Docket Number:	09-AFC-05C
Project Title:	Abengoa Mojave Compliance
TN #:	200121
Document Title:	Abengoa Mojave Solar's Responses to CEC's Informal Data Request
Description:	N/A
Filer:	Tiffani Winter
Organization:	Ellison, Schneider & Harris L.L.P.
Submitter Role:	Applicant's Representative
Submission Date:	8/7/2013 3:34:47 PM
Docketed Date:	8/7/2013

Re: Mojave Solar Project (09-AFC-05C) Responses to Informal Data Requests

DATA RESPONSES

**Engineering Document
6007-PLN-GAU-58-62-0001 REV 2**

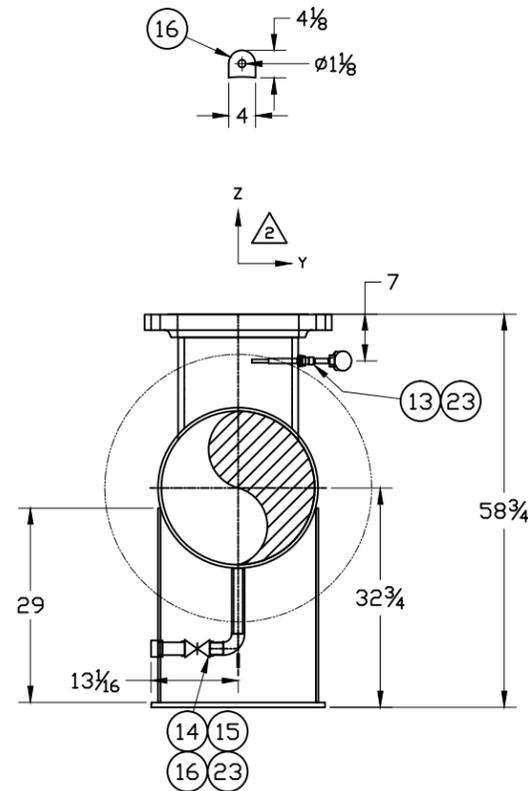
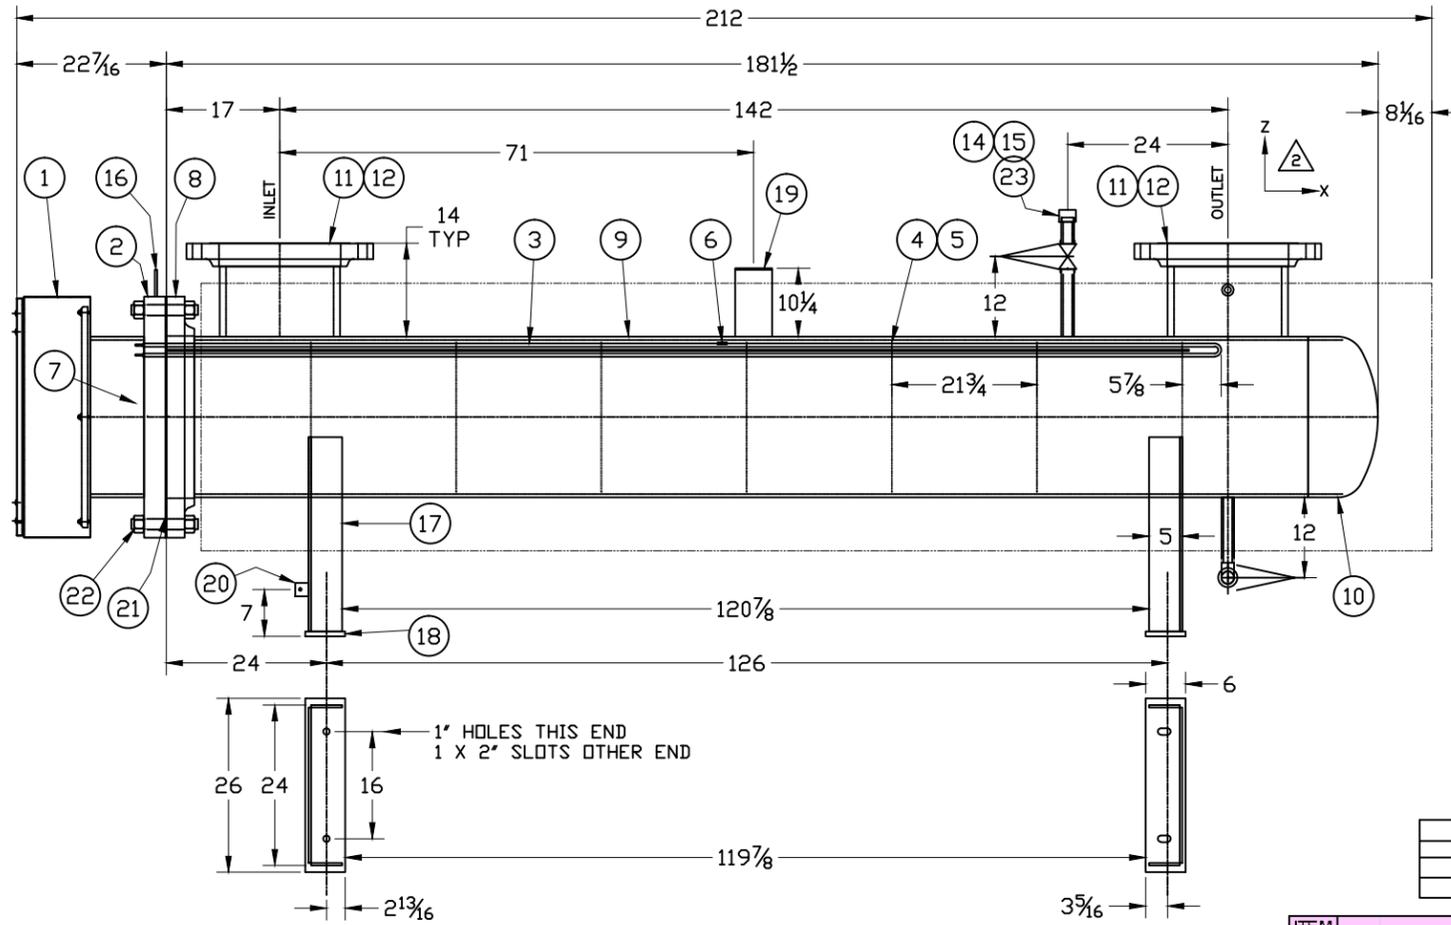
1. Please provide more details about the exact heater being proposed.

Attached are three engineering documents that provide additional information regarding the proposed electric heaters. Attachment 1 (6007-PLN-GAU-58-62-0001 Rev2) provides a general arrangement drawing. Attachment 2 (6007-PLN-GAU-58-62-0004.0) provides tube bundle details. Attachment 3 (6007-PLN-GAU-58-62-0005) is a diagram of the 24” enclosure and wiring.

**Engineering Document
6007-PLN-GAU-58-62-0004.0**

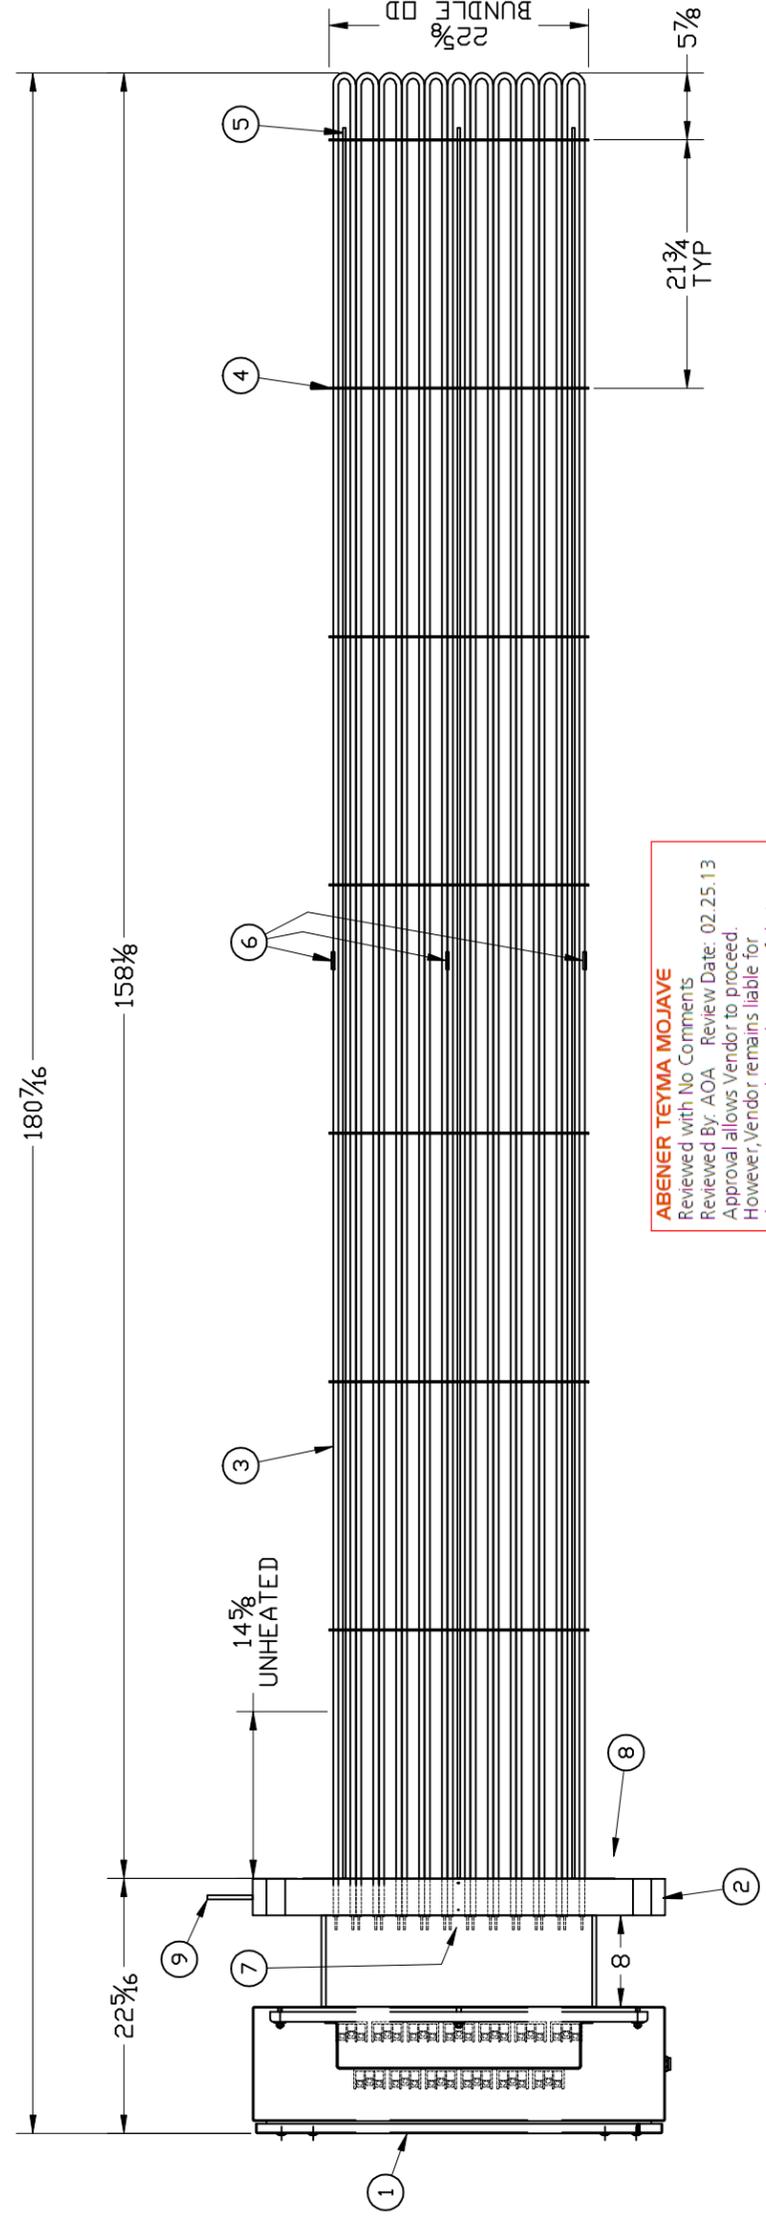
2. Will the heat transfer fluid (“HTF”) be heated directly by a heating element immersed in HTF?

3. Will the HTF be heated indirectly by heating a vessel which then transfers heat to the HTF?

The HTF electric heaters will operate similar to a shell and tube heat exchanger. As shown on Attachment 2, heating filaments are enclosed inside the tubes. The HTF will flow through the vessel around the tubes. As a result, the HTF is indirectly heated since the filament heats the tube, and the tube heats the HTF.
